RE: San Diego Gas & Electric Company's Response to Notice of Violation – NOV\_CAD\_SDGE\_SIS\_20250325\_0809

## A. Violation 1 – Failure to Complete Covered Conductor Installation on Pole ID P879035.

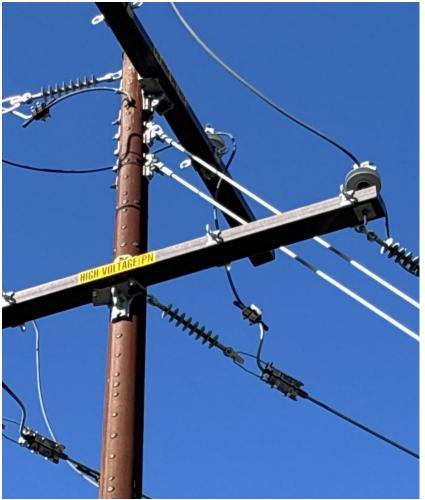
Violation 1 – Energy Safety observed that in implementing 2024 WMP initiative 8.1.2.1 - Covered Conductor Installation (WMP.455), SDG&E failed to complete Covered Conductor Installation on pole ID P879035, Grid Hardening ID P879035\_0073-R-CC\_3243 at coordinates 32.7637217031741, 116.688607731081. Energy Safety considers this completeness violation to be in the Moderate risk category.

The issue concerning the down guy insulator in contact with the crossarm suspension dead-end insulator was resolved on Thursday April 24th, 2025. See the photo below as evidence of the repairs.
